Access Compliance Report

Public Rights-of-Way

Intersection ID: 12333	Main Street: N_BREVARD_ST	Cross Street: E_7TH_ST	Location:	W
ADA ID: AB25536D8C04	Ramp Type: Perp	Initial Pass/Fail: Fail	Overall Compliance: No	Severity Score: 12.5
Codes/Mitigation Info/Possible Solution		Field Measurements/Component Compliance

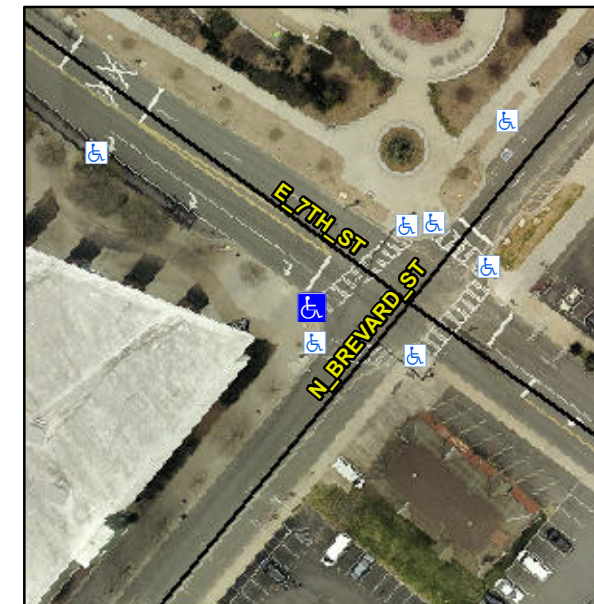
Damaged DWS

Not Found, R304.2.2

Compliance	Description	Data	Compliance	Description	Data
N/A	Ramp Length (in)	72.0	No	Ramp Slope (%)	9.0
Yes	Ramp Width (in)	48.0	Yes	Ramp XSlope (%)	1.8
N/A	Flare Type LT	N/A	N/A	Flare Type RT	N/A
N/A	Flare Slope LT (%)	N/A	N/A	Flare Slope RT (%)	N/A
N/A	Flare Traversable LT?	N/A	N/A	Flare Traversable RT?	N/A
N/A	Landing Length (in)	N/A	N/A	DWS Provided?	N/A
N/A	Landing Width (in)	N/A	N/A	DWS Contrast?	N/A
N/A	Landing Slope (%)	N/A	N/A	DWS Length (in)	N/A
N/A	Landing X Slope (%)	N/A	N/A	DWS Full Width?	N/A
N/A	Landing Curb? (Y/N)	N/A	N/A	DWS Offset (in)	N/A
N/A	Shared Landing?	N/A			
N/A	Gutter Ponding?	N/A	N/A	Gutter Slope (%)	N/A
N/A	Gutter Lip Ht (in)	N/A	N/A	Gutter X Slope (%)	N/A
N/A	Painted X Walk1?	Yes	N/A	Painted X Walk2?	N/A
	X Walk 1 Direction	To NE		X Walk 2 Direction	N/A
N/A	X Walk 1 Width (in)	108.0	N/A	X Walk 2 Width (in)	N/A
	X Walk 1 Slope (%)	1.5		X Walk 2 Slope (%)	N/A
	X Walk 1 X Slope (%)	2.5		X Walk 2 X Slope (%)	N/A

Remove & Replace Entire Ramp.
